**TOWN OF NEWBURGH
PLANNING BOARD
TECHNICAL REVIEW COMMENTS**

PROJECT NAME: 217 S. PLANK ROAD-CANNABIS DISPENSARY
PROJECT NO.: 24-13
PROJECT LOCATION: SECTION 61, BLOCK 1, LOT 18 &19
REVIEW DATE: 12 JULY 2024
MEETING DATE: 18 JULY 2024
PROJECT REPRESENTATIVE: MINUTA ARCHITECTURE

PLANNING BOARD NARRATIVE

Re: PB #24-13, 217 S. Plank Road, S-B-L: 61-1-19.2

BOUNDARY SURVEY
 LOCATED AT
217 SOUTH PLANK ROAD
 TOWN OF NEWBURGH
 ORANGE COUNTY NEW YORK
 CV ASSOCIATES NY, P.E., L.S., P.C.
 148 ROUTE 17M SUITE 2, HARRIMAN, NY 10926

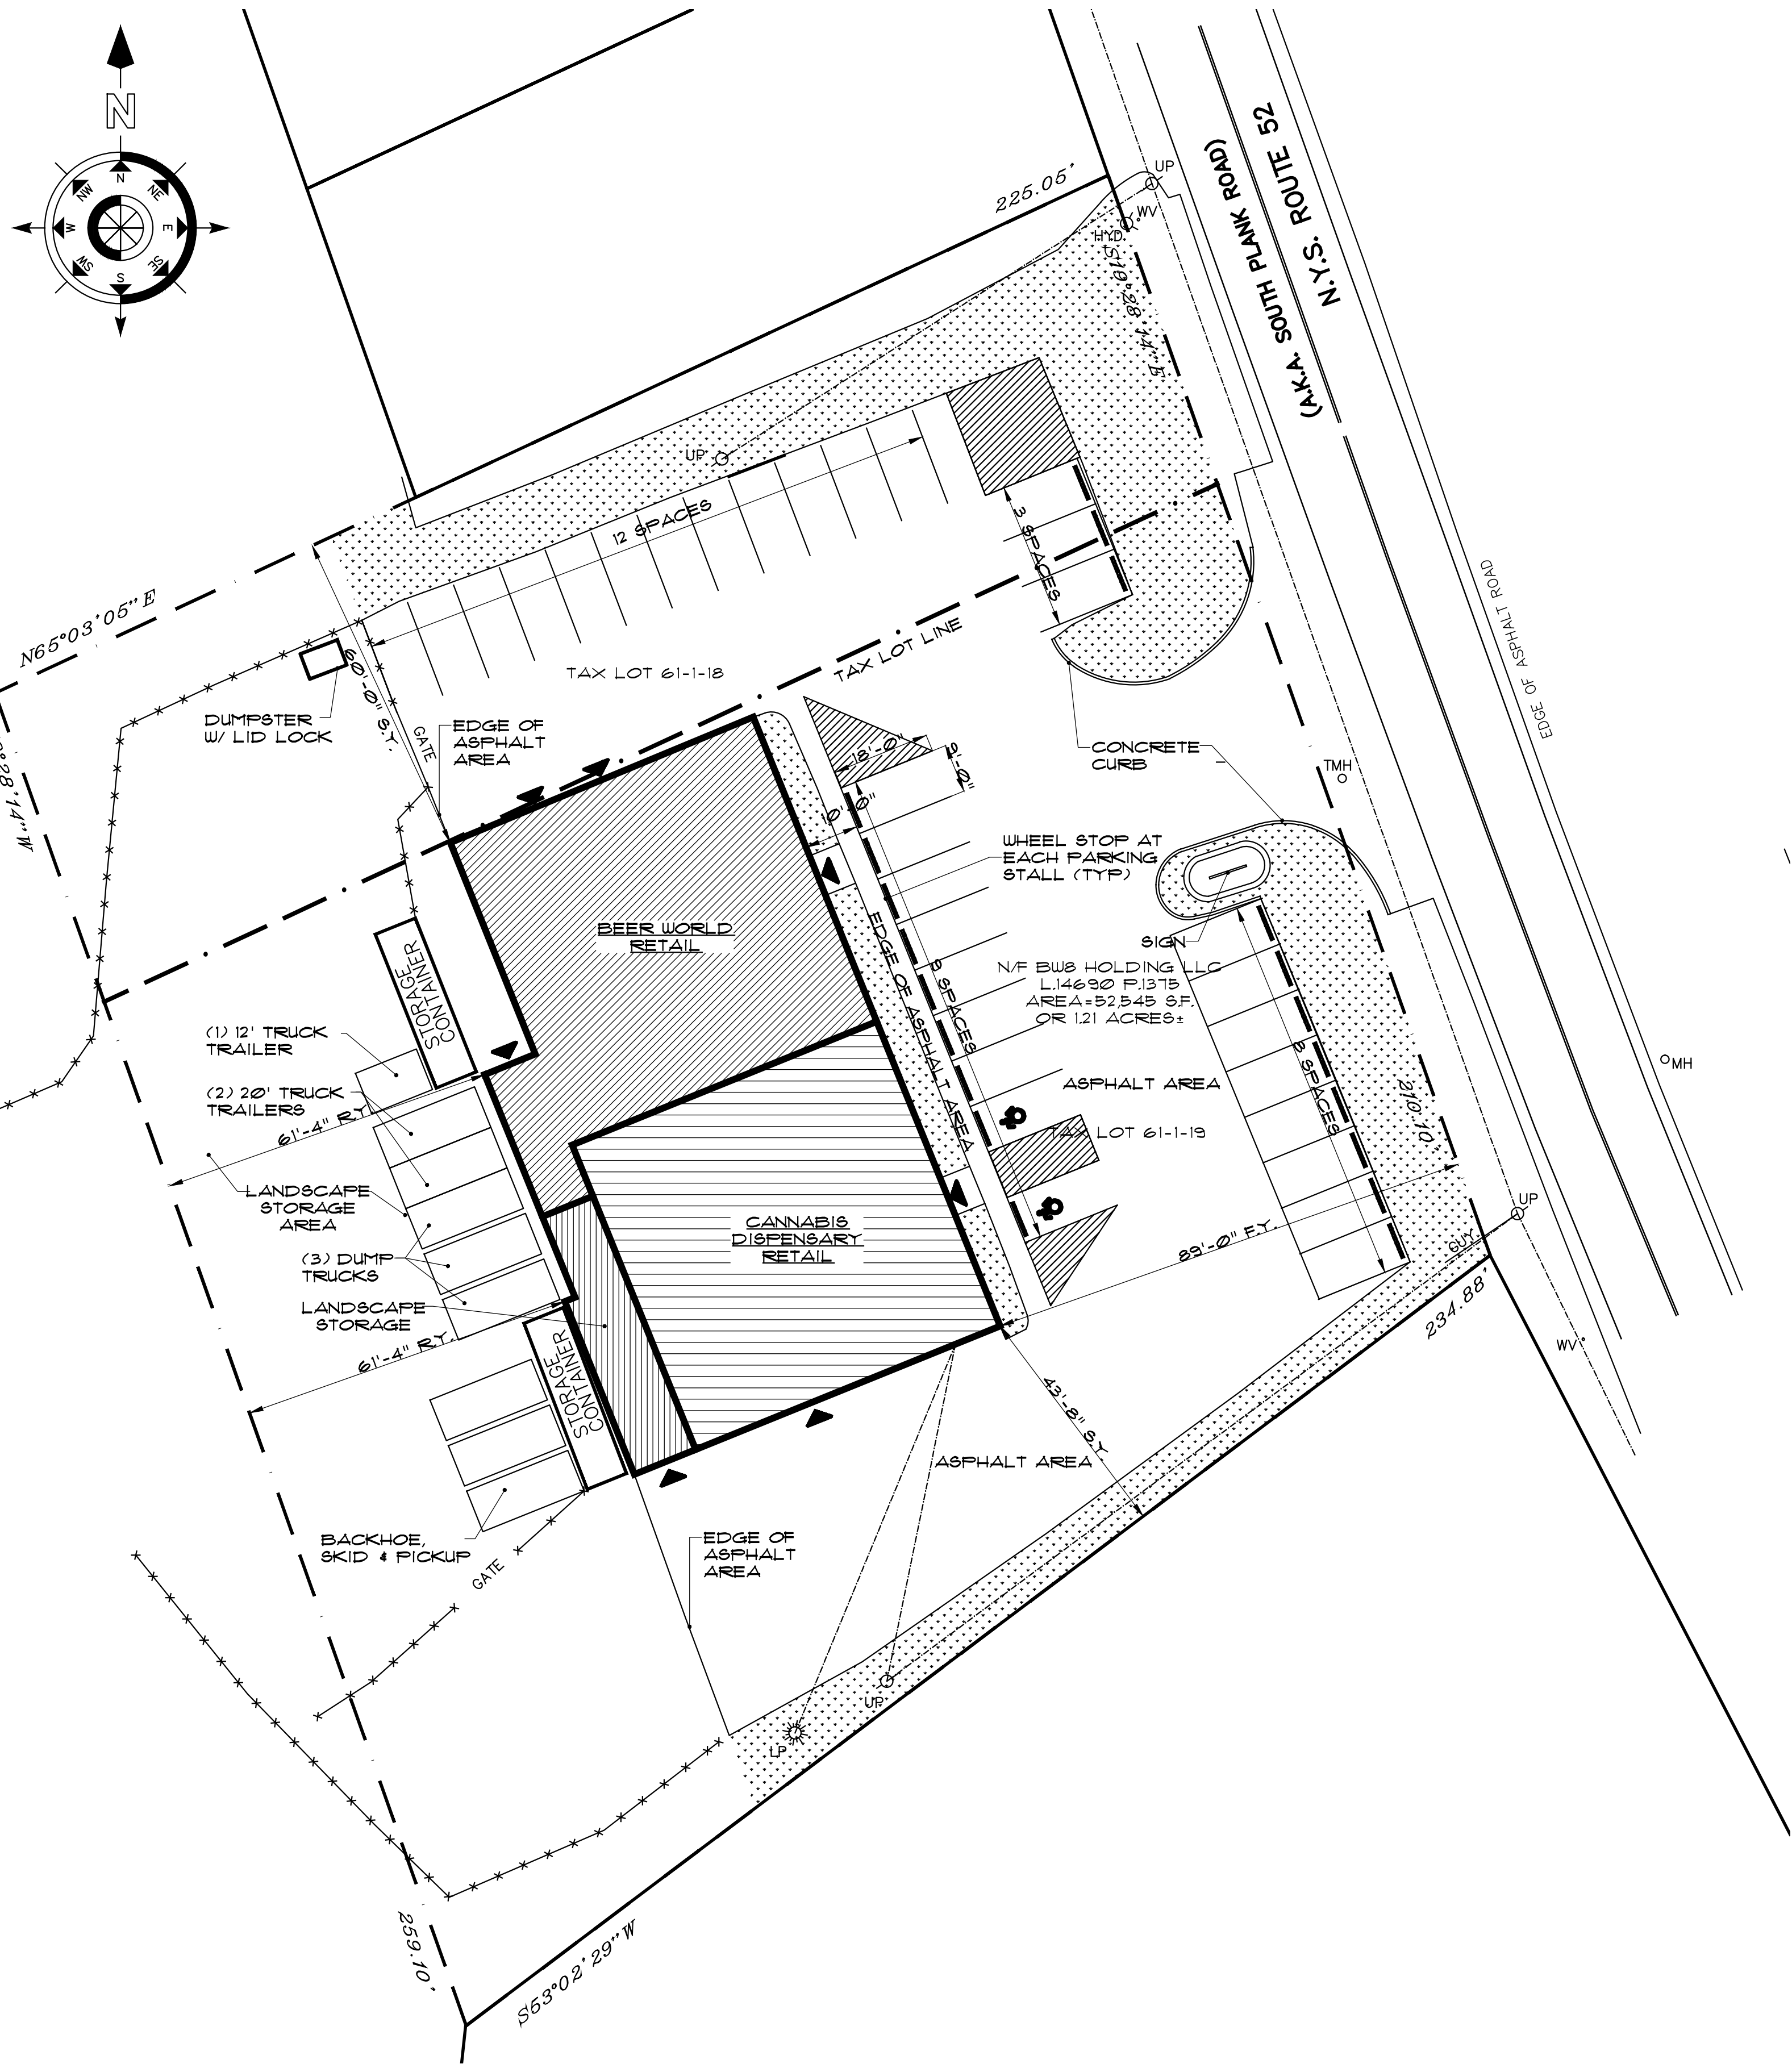
3. Updated Survey Map identifies areas to the rear of the parcel utilized for landscaping under the previously approved Site Plan.
4. Jim Campbell's comments regarding the architectural features identifying the five leaf arrangement in the sign should be reviewed with regard to Section 185-49C(4) Sales Product and Paraphenallia items related to the preparation or consumption of products shall not be visible off-site or from a public right-of-way.

Plan S-1 depicts the areas at the rear of the property that comports with the original site plan approval of 2004.

4 Typical Sign Detail
 S-2 Scale: 1/4" = 1'-0"

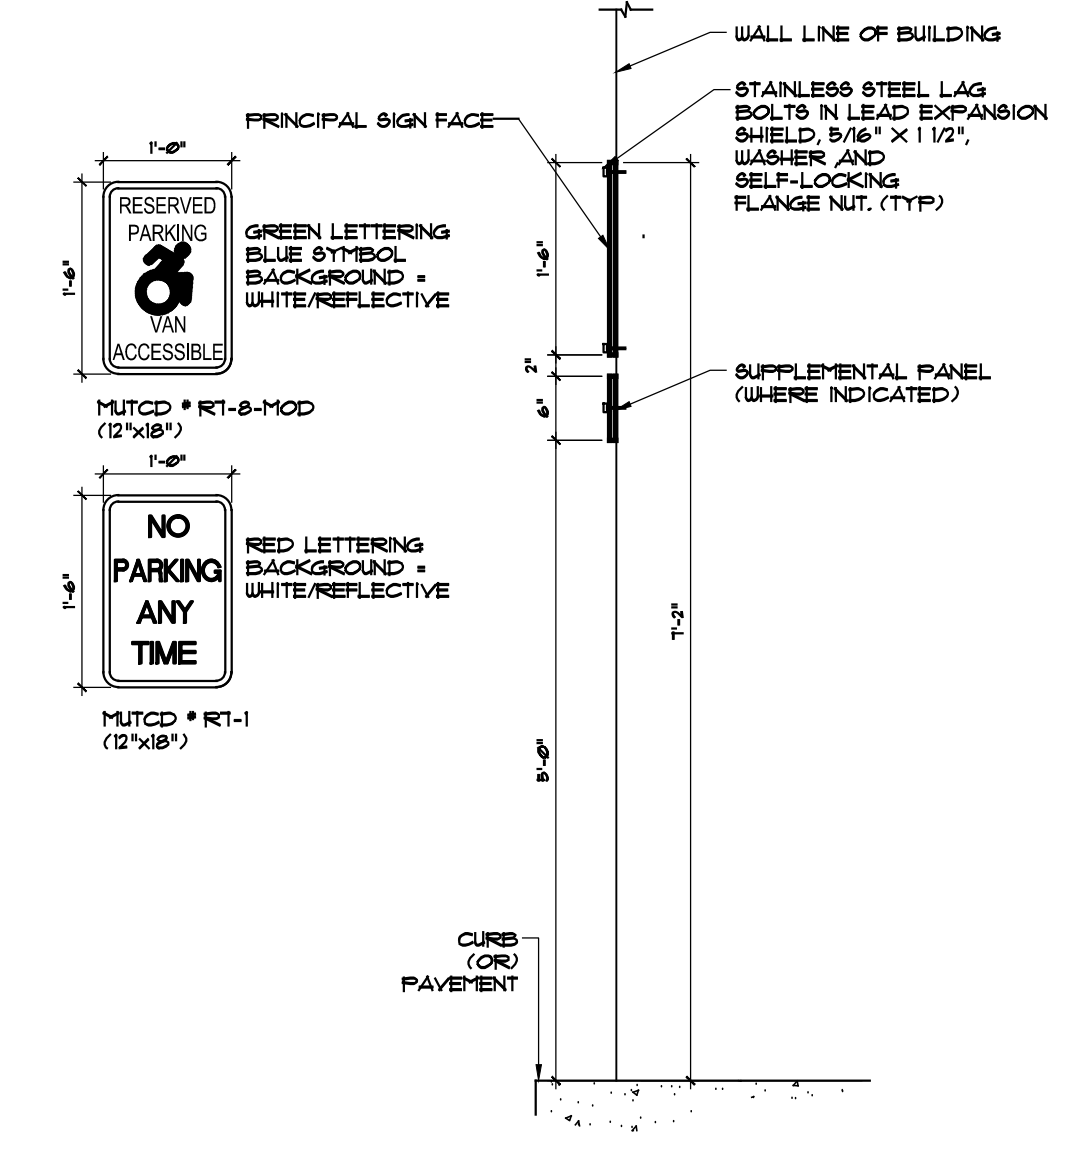
5. The application materials identify that the entire site will be seal coated and re-stripped for parking in compliance with Town of Newburgh Code.
6. Submission was made to County Planning on 25 June 2024.
